Firestop Submittal Package

078446-Fire-Resistive Joint Systems

Project: Webster University ISB - Drywall SP

SUBMITTAL IDENTIFICATION SHEET

A0104.A

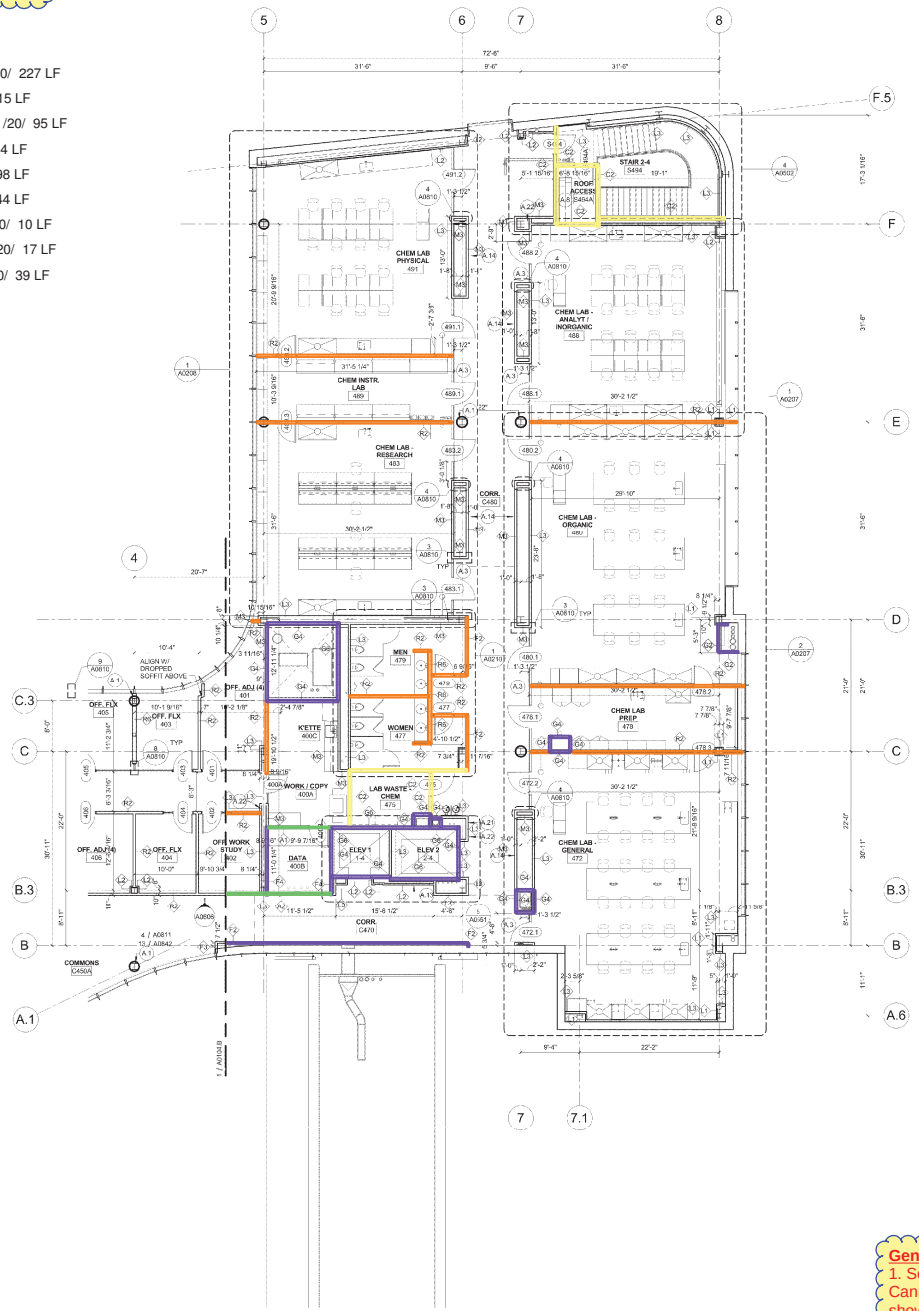
These 'R-' partition types are not fire rated partitions (per sheet A1001) and do not require any fire stopping.

1. See the two sheets that were added into this submittal by CannonDesign (right before Hilti's marked up plans) which show the intended rated partitions vs. the "rated" partitions not correctly shown within this submittal as it was submitted (due to confusion on partition types "R-" & "V-" which are not fire rated partitions - they are only sound rated).

2. Rated cmu walls did not appear to be accounted for within the Hilti marked up plans. CannonDesign assumes that these cmu walls need fire stopping too.

A0104.B

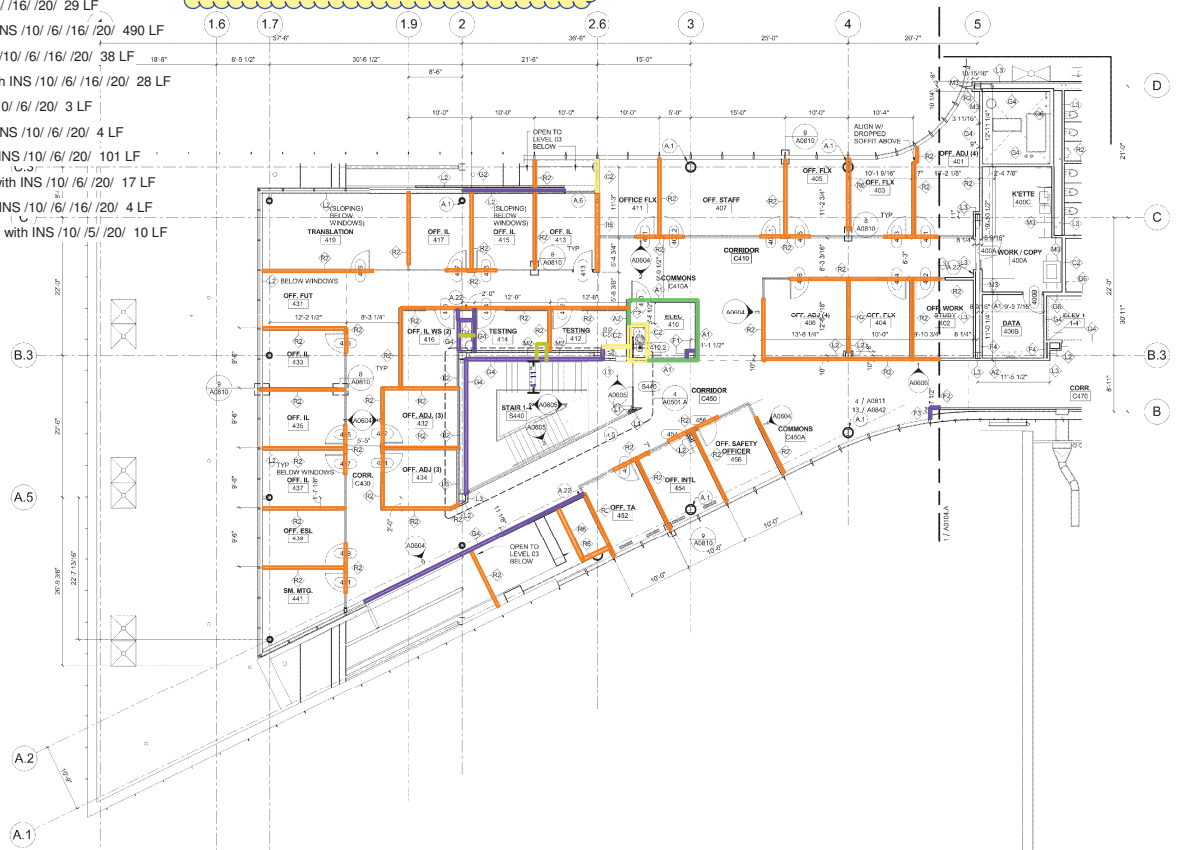
These 'R-' partition types are not fire rated partitions (per sheet A1001) and do not require any fire stopping.

1. See the two sheets that were added into this submittal by CannonDesign (right before Hilti's marked up plans) which show the intended rated partitions vs. the "rated" partitions not correctly shown within this submittal as it was submitted (due to confusion on partition types "R-" & "V-" which are not fire rated partitions - they are only sound rated).

2. Rated cmu walls did not appear to be accounted for within the Hilti marked up plans. CannonDesign assumes that these cmu walls need fire stopping too.
